Lime Down

Solar Park

Applicant's Response to SLD Deadline 6 Submission - Hydrology [REP5-130]

Planning Inspectorate Reference: EN010168

Figure 1: Illustrative simulated soil water content beneath solar PV panels reproduced by SLD

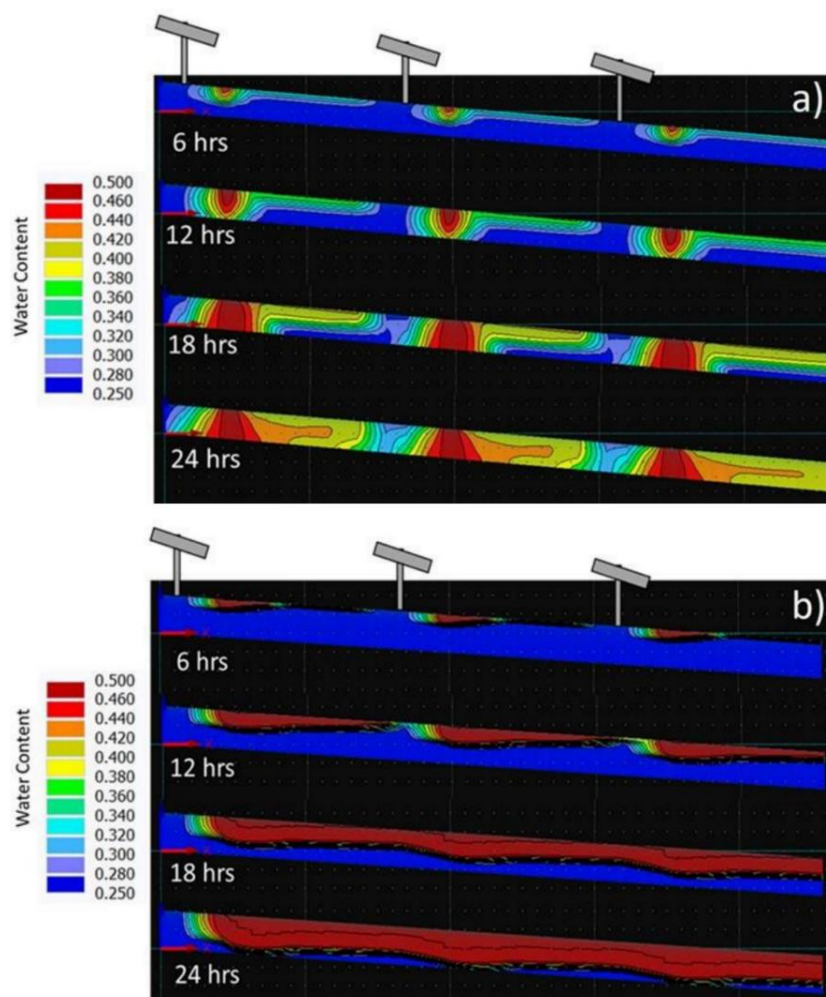
- 2.1.2 SLD also referred at ISH5 to the image reproduced at Figure 1 below when discussing the response of water beneath solar PV panels. For clarity, this image is not an output generated by the PV-SMaRT Solar Runoff Calculator for Lime Down. It is a static visualisation reproduced by SLD from the research underpinning the development of PV-SMaRT.

- 2.1.3 The figure shows simulated soil water content at 6, 12, 18 and 24 hours for two illustrative soil conditions. The colour scale represents soil water content. It does not show measured runoff at Lime Down, a Lime Down runoff rate, a modelled Lime Down hydrograph, runoff leaving a Solar PV Site or a downstream flood response.

- 2.1.4 The distinction is important because the PV-SMaRT calculator used by SLD and the Applicant is a spreadsheet-based plot-scale calculator which produces numerical expected runoff outputs from the assumptions entered by the user. It does not recreate the spatial soil-water simulation shown in Figure 1. Figure 1 therefore provides context on the research underpinning PV-SMaRT, but it is not a site-specific PV-SMaRT output for Lime Down and does not show runoff rates or downstream flood effects at Lime Down.
